Ref: DAQRI LLC – Permissive Changes FCC ID 2AEWMDQR002001 IC ID 22854-DQR002001

The DAQRI Compute Pack has two principle basic mechanical changes.

Both antennas moved from the central (side), vented area to the inner plastic cover under belt clip.

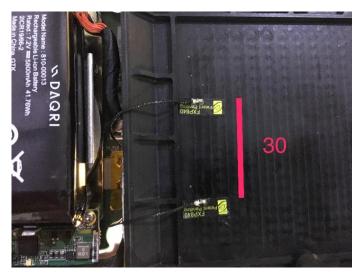
Old Position, on middle housing

New Position, on inner plastic cover
